CITY OF ALBUQUERQUE

RE: Volcano Cliffs Unit 5 lot 33 block 8 SAD 227 7900 Marigold Dr. NW

Grading and Drainage Plan

Based upon the information provided in your submittal received 1/25/2023, this plan is approved for Building permit.

SHEET# C1 JOB#

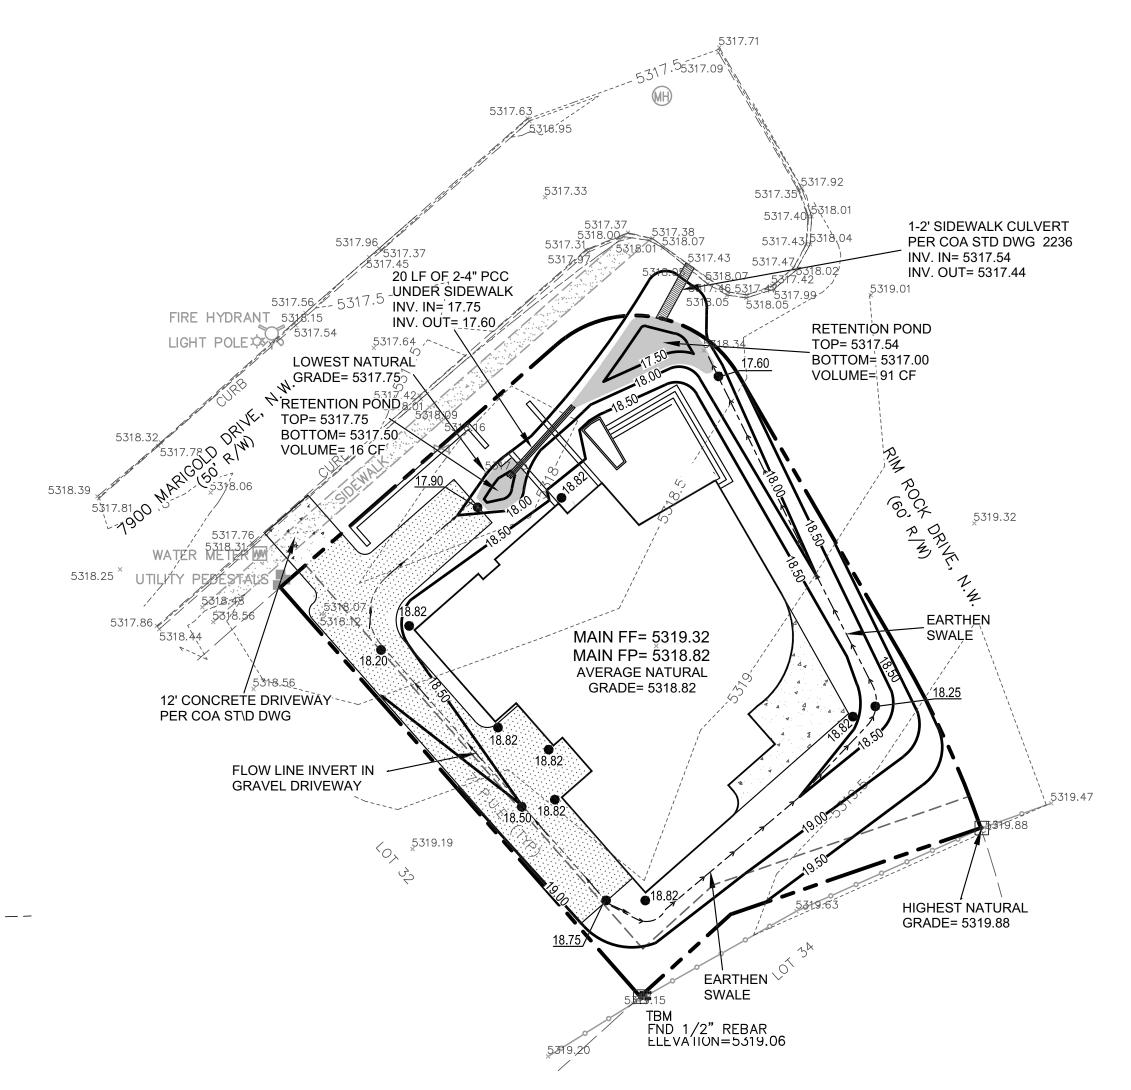
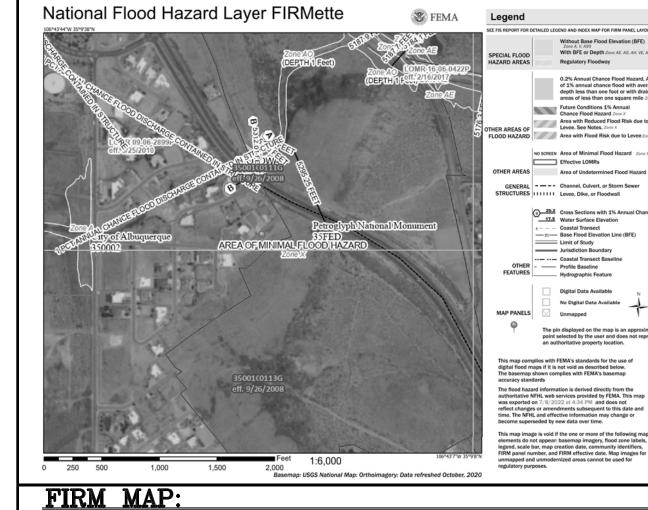
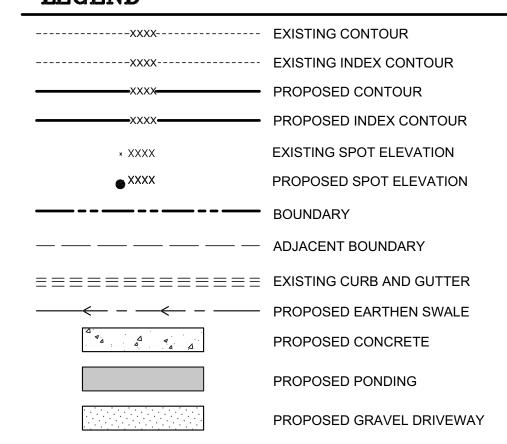
Reiterate to the Owner/Contractor that a separate permit for a garden/retaining wall must be obtained, with the approved G&D plan and Pad Certification. Inform the owner & Contractor that dirt is not allowed in the public right of way to climb the curb. Crusher fines or lumber are allowed. If dirt is used this will delay the permitting process.

Prior to Certificate of Occupancy release, Engineer Certification per the DPM checklist of this plan will be required.
